**SUBDIVISION COMMITTEE
METROPOLITAN AREA PLANNING COMMISSION**

STAFF REPORT

S/D 97-25 - BRADFORD NORTH 3RD ADDITION

STAFF REPORT
(Preliminary Plat)

VICINITY MAP:

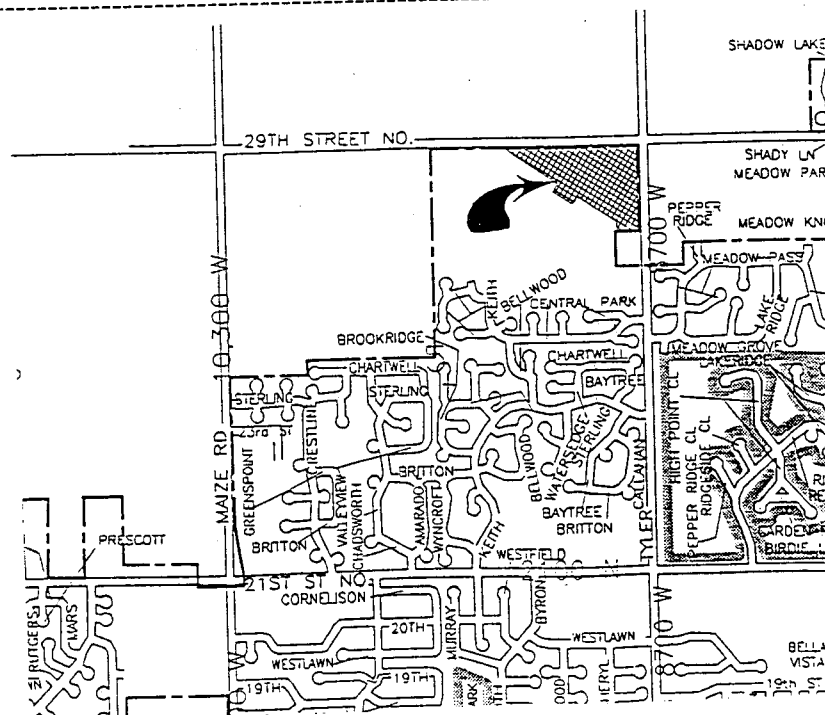
NOTE: When the area to the south of this plat was being platted, a street connection was provided in order to connect that plat with this site in the event residential development was eventually planned for the area now being platted. That street connection was provided in the area now being platted as Lot 18, Block 1. This plat is, therefore, indicating its intention to not provide for any such integration of residential areas.

Also, when property to the east of Tyler Road platted (Northridge Lakes) the pipe line crossing that site, (the same as crosses this site), was included within a Reserve, rather than being allowed as part of platted lots. Such platting of pipeline areas as Reserves is intended to provide a greater degree of safety by preventing numerous lot owners from carrying out activities in such areas, but also such long Reserves can be used as recreational corridors if properly developed as part of an Addition. This plat, however, is proposing to place all of the pipeline easement, setbacks, etc. as portions of lots. For a number of lots, this is resulting in what appears to be large lots, but what are in essence extremely limited as usable area.

Further, this site will need to obtain a zone change in order to reflect the development now being planned. Typical "LC" zoning exists at the southwest corner of Tyler and 29th Street North. However, the applicant is indicating that a portion of this area is being platted for residential, "TF-3" uses. Consequently, all such residential areas need to be zoned to that classification, including those lots not now covered by "LC" zoning. For Lot 15 of Block 3, the southern one-third of that lot, does not have "LC" zoning and will, consequently, need an appropriate zone change for that portion of the lot.

- B. The applicant shall guarantee the extension of sanitary sewer to serve the lots being platted. As requested by City Engineering, a sewer layout plan shall also be provided to City Engineering. If sewer is planned along the north line of this plat, City Engineering needs to indicate if the 15-foot easement, as shown, is adequate.

- F. The applicant shall guarantee the paving of the proposed interior streets. This guarantee shall also provide for sidewalks along one side (south side) of the through street (Meadow Park) running from Tyler to 29th Street North.

- J. The applicant's agent shall determine any setback requirements from the pipeline by researching the text of the pipeline agreement. If a setback from the pipeline easement is provided for in the pipeline easement agreement, it shall be indicated on the face of the plat.

- K. Any relocation, lowering or encasement of the pipeline, made necessary by this development, will not be at the expense of the City.
- L. On the final plat tracing, dimensions from lot corners shall be shown for lots 1 and 16 in Block 1 so as to better locate the easements along these lots' side property lines.

- M. On the final plat tracing, the plat's text shall be revised to properly reference the dedication of access control. Specifically, the present wording should be expanded to note that the access control is being granted to the City of Wichita (as indicate in the face of the plat), with the location of openings to be approved by the City Engineer.

- O. On the final plat tracing, the building setback on Lots 1, 2, and 3, Block 3 shall be labeled.

Below the north arrow, the legend shall also note that S.B. is for the Building Setback. Also, if the "control point" stands for iron or rebar set, the legend should also note that for the dot symbol.
- P. The applicant is reminded that all applicable property taxes must be paid before a plat can be recorded.

VICINITY MAP:

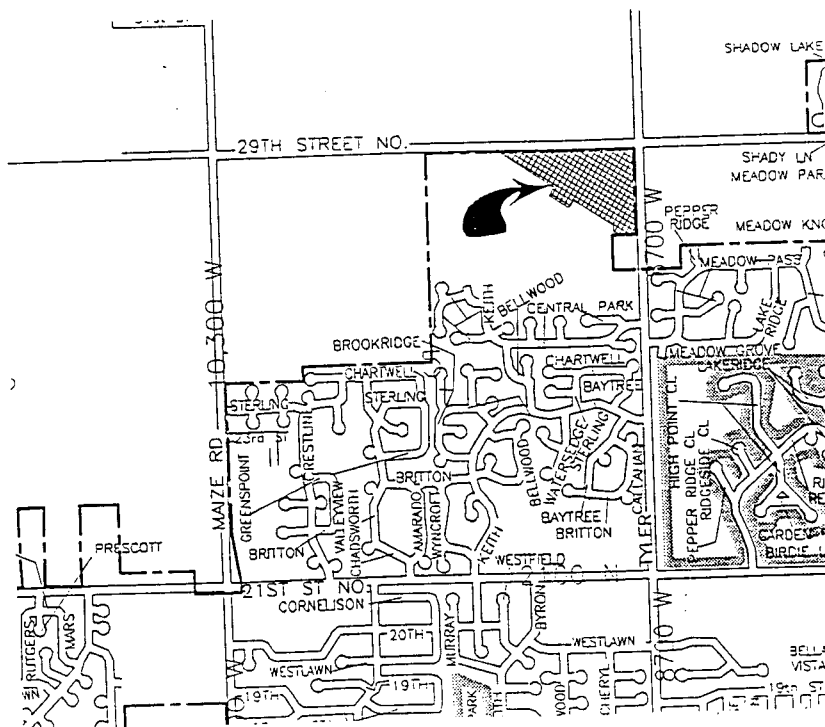
NOTE: When the area to the south of this plat was being platted, a street connection was provided in order to connect that plat with this site in the event residential development was eventually planned for the area now being platted. That street connection was provided in the area now being platted as Lot 18, Block 1. This plat is, therefore, indicating its intention to not provide for any such integration of residential areas.

Also, when property to the east of Tyler Road platted (Northridge Lakes) the pipe line crossing that site, (the same as crosses this site), was included within a Reserve, rather than being allowed as part of platted lots. Such platting of pipeline areas as Reserves is intended to provide a greater degree of safety by preventing numerous lot owners from carrying out activities in such areas, but also such long Reserves can be used as recreational corridors if properly developed as part of an Addition. This plat, however, is proposing to place all of the pipeline easement, setbacks, etc. as portions of lots. For a number of lots, this is resulting in what appears to be large lots, but what are in essence extremely limited as usable area.

Further, this site will need to obtain a zone change in order to reflect the development now being planned. Typical "LC" zoning exists at the southwest corner of Tyler and 29th Street North. However, the applicant is indicating that a portion of this area is being platted for residential, "TF-3" uses. Consequently, all such residential areas need to be zoned to that classification, including those lots not now covered by "LC" zoning. For Lot 15 of Block 3, the southern one-third of that lot, does not have "LC" zoning and will, consequently, need an appropriate zone change for that portion of the lot.

- C. The applicant shall guarantee the extension of sanitary sewer to serve the lots being platted. As was noted for recent plats in this area, limitations on sewer service in this area are occurring. City Engineering needs to indicate if this site is impacted by any such limitations.

- R. On the final plat, dimensions for lot corners shall be shown for lots in Block 1 so as to better locate the easements along the rears of these lots.

- J. For Lot 17, Block 3, 100-feet of complete access control shall be shown from the lot's northeast corner to both Tyler and 29th Street North.
- K. The final plat shall state in the platter's text the purposes of the proposed reserves as well as who is to own and maintain the reserves.

- M. The applicant shall submit a copy of the instrument which establishes the Arkansas Louisiana Gas Company Pipe Line Easement on this property. The applicant's agent shall determine any setback requirements from the pipeline by researching the text of the pipeline agreement. If a setback from the pipeline easement is provided for in the pipeline easement agreement, it shall be indicated on the face of the plat.

- N. Any relocation, lowering or encasement of the pipeline, made necessary by this development, will not be at the expense of the City.
- O. On the final plat, it shall be more clearly noted as to utilities within Reserves. Only Reserve F appears to show an easement for utilities while the note on the preliminary plat implies utilities and easements are to be provided within all of the Reserves.

- P. On the final plat, it appears that the appropriate street names for this site would be Meadow Park for the entire length of the diagonal street segment, with Meadow Park Court for the two cul-de-sac sections. The Fire Department representative needs to confirm appropriate street names for this Addition.

- Q. On the final plat, open areas or dashed lines shall be used to indicate where Meadow Park (Drive/Lane) intersects 29th Street North and Tyler Road. Solid lines are used to indicate private streets, platted as Reserve.
